ADDENDUM NO. 1 TO PROJECT NO. M3187

CONSTRUCTION WORK REPLACE ROOFS BUILDINGS 9, 10, 11, 58, 75, 79, 80, 82 & 83 HUDSON CORRECTIONAL FACILITY 50 EAST COURT STREET HUDSON, NEW YORK

July 10, 2026

A-301

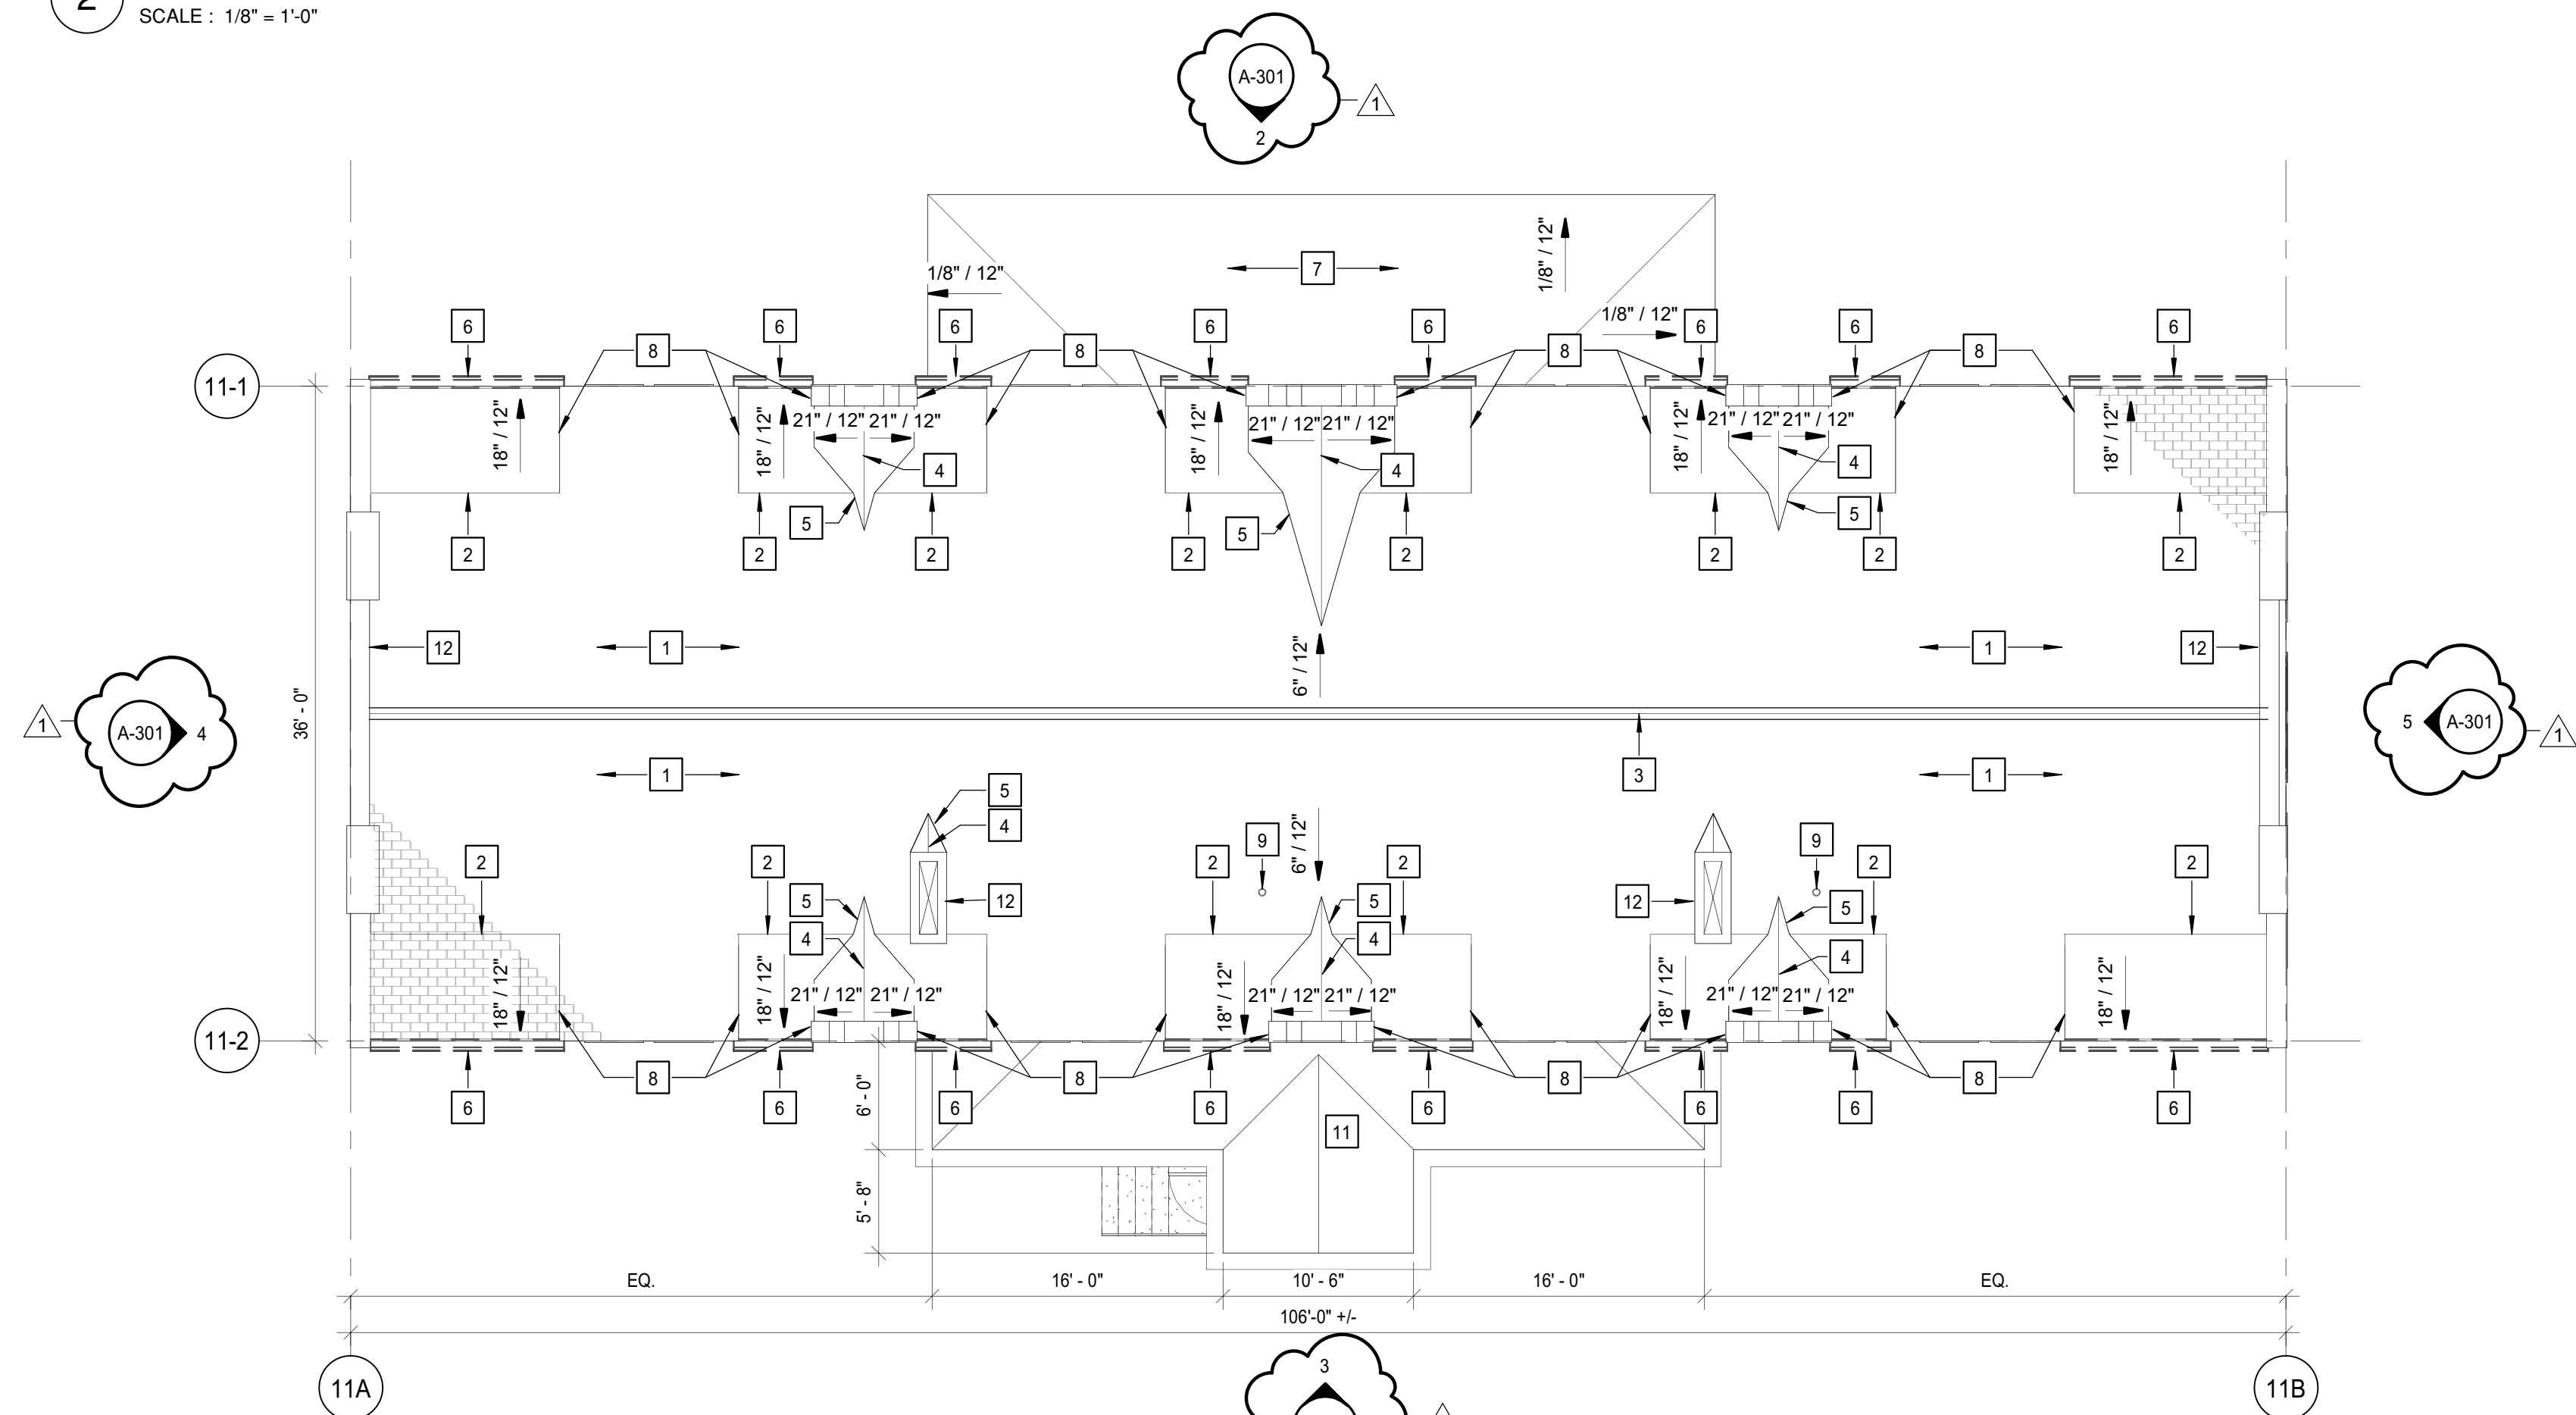
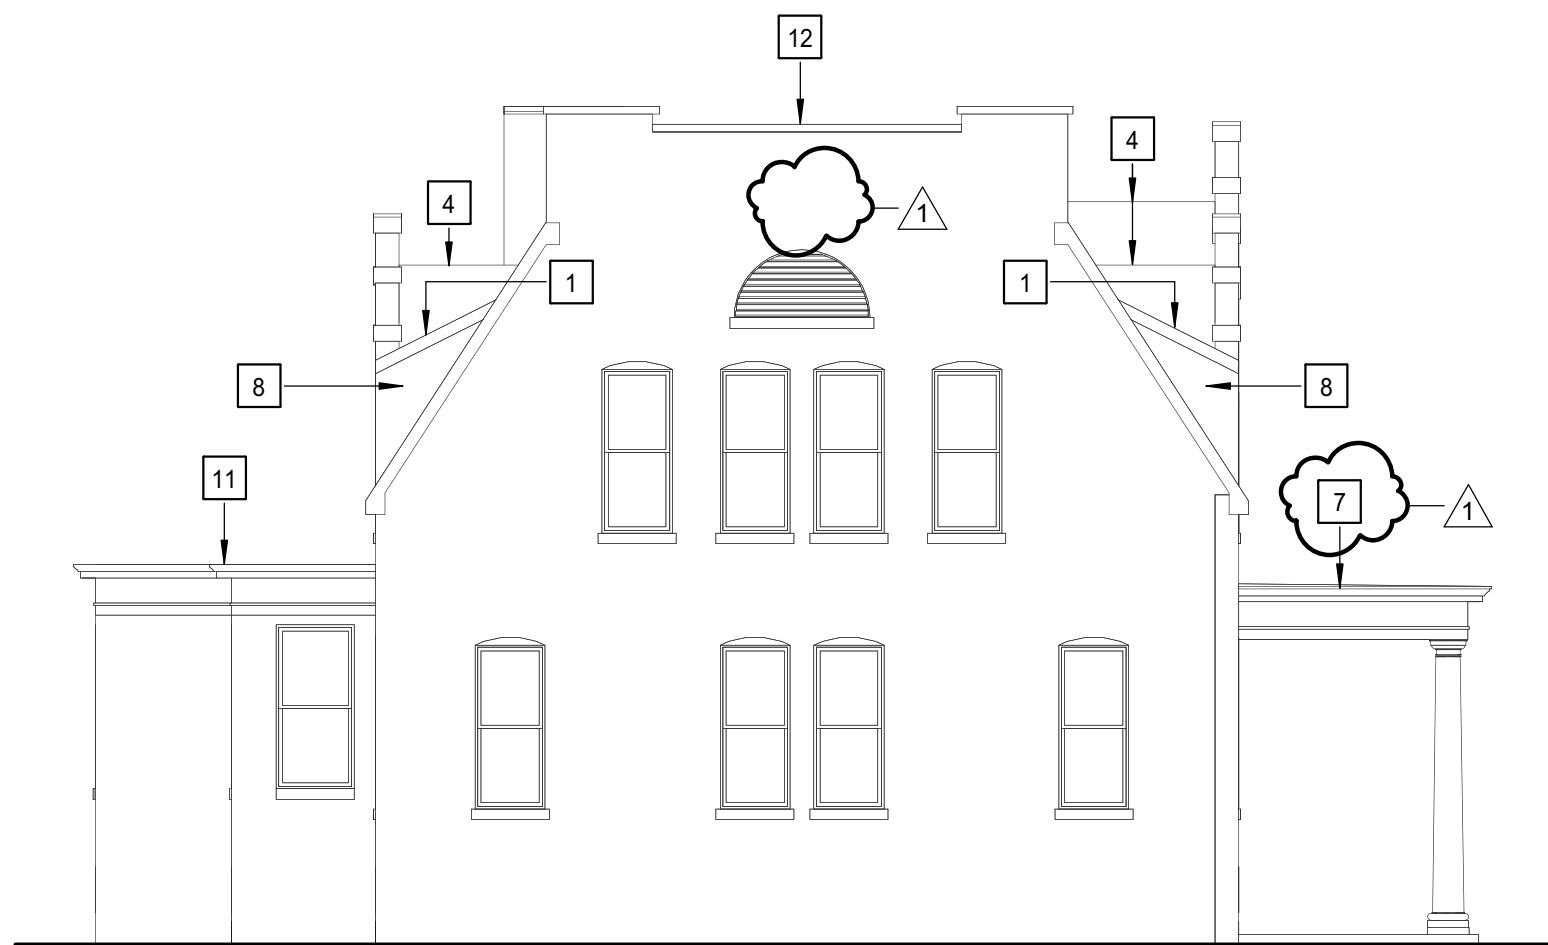
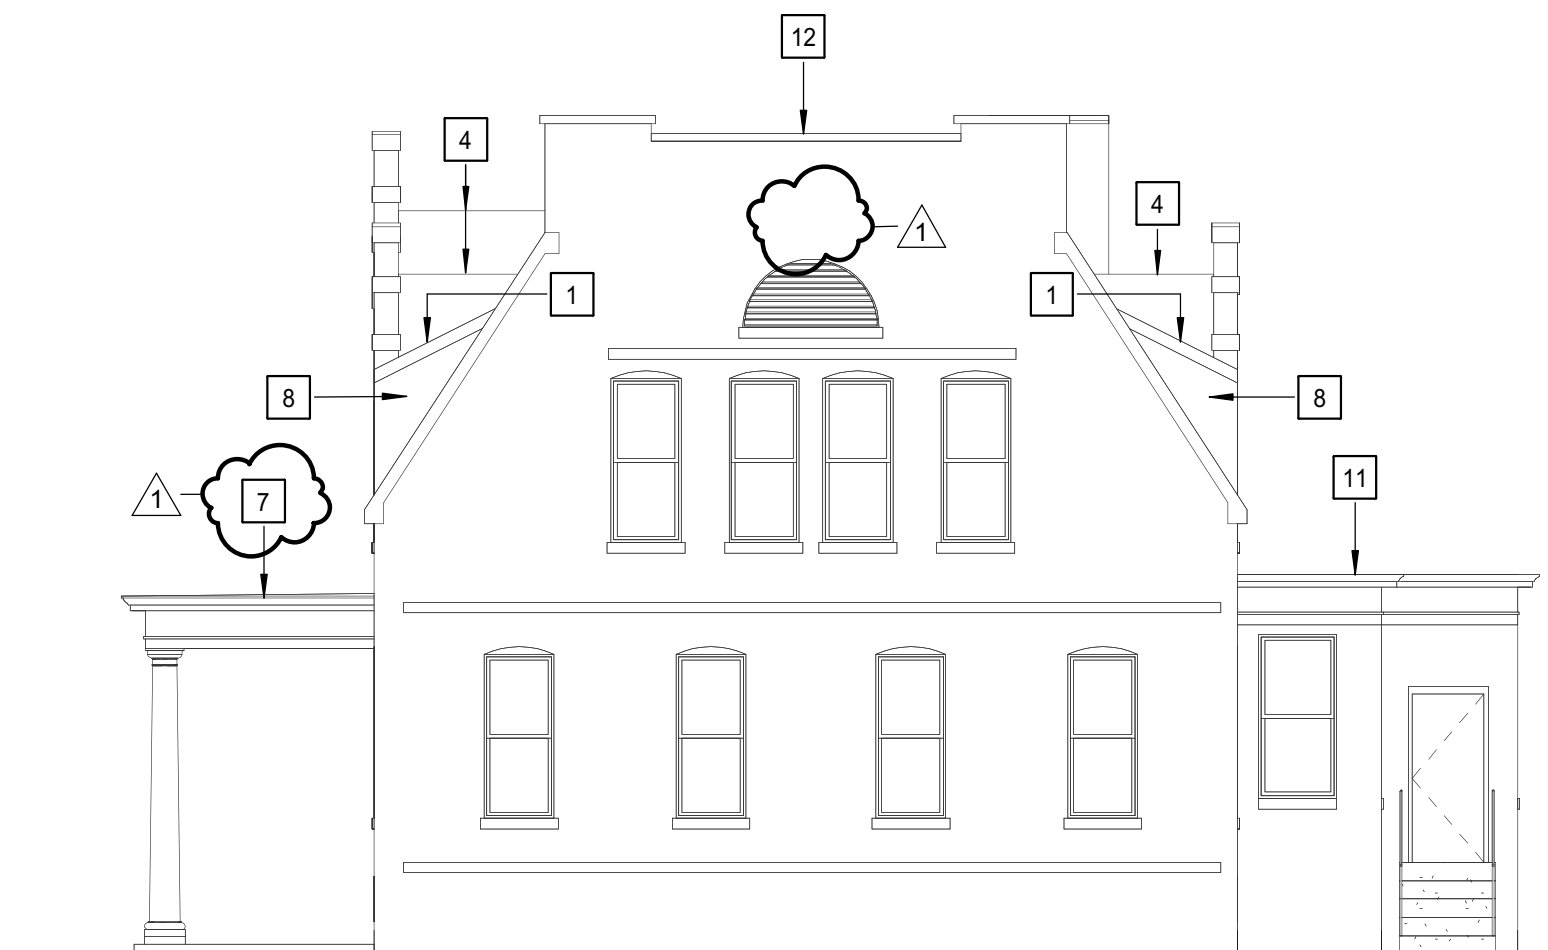
3. Revised Drawings:
 - a. Drawing Nos. A-201, A-301, A-401 and A-501, noted “ADDENDUM 01”, dated 7/09/2026, accompany this Addendum and supersedes the same numbered previously issued drawings.
4. Drawing No. A-402
 - a. KEYED NOTES, Change Note 13 to Read:
